APPLICATION NO.	FILING DATE	FIRST NAMED INVENTOR	ATTORNEY DOCKET NO.	CONFIRMATION NO.
10/026,151	12/19/2001	Ertugrul Berkean	RD-28,476	8199

KARLSEN, ERNEST F

Office Action Summary

FIG. 2

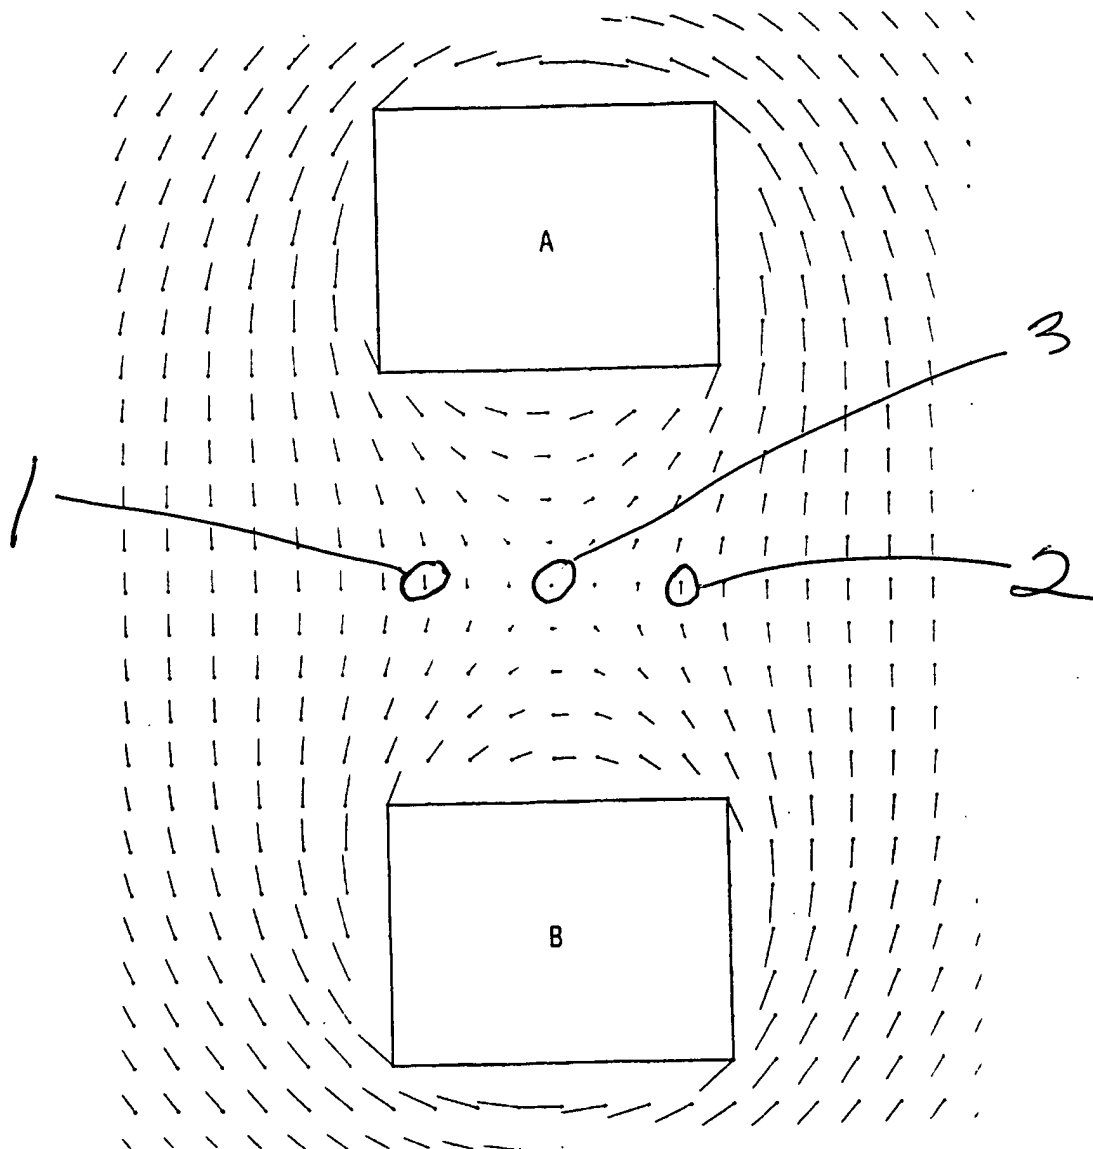
The above figure is Figure 2 of Ladds.

Claims 1-3, 6,7,10-13, 16,17, 20,30 and 31 are rejected under 35 U.S.C. 102(b) as being anticipated by Ladds. In Ladds, Figure 4 shows the position of devices H1 and H2 relative to conductors A and B. The Examiner has included a copy of Ladds Figure 2 above and has indicated positions 1, 2 and 3. Presumably H1 is at position 1 and H2 is at position 2. Ladds indicates that H1 and H2 could be positioned in various ways but seems to like the arrangement of Figure 4 best. The Examiner notes that the assembly of H1 and H2 could be rotated to any position about point 3 of Ladds Figure 2 and still be properly operational. Note that in Ladds, Figure 2, the arrow at position 1 is down and the arrow at position 2 is up. Ladds subtracts the output of H1 from H2 or vice versa to obtain 2 times the desired signal and cancellation of undesirable signals. The whole specification of Ladds is of interest. It is only 3.5 columns long. Further note that if the support for H1 and H2 of Figure 2 were rotated 90 degrees H1 and H2 would still be responding to up and down fields and that is why Ladds encompasses plural locations for the support (an IC package) for H1 and H2.
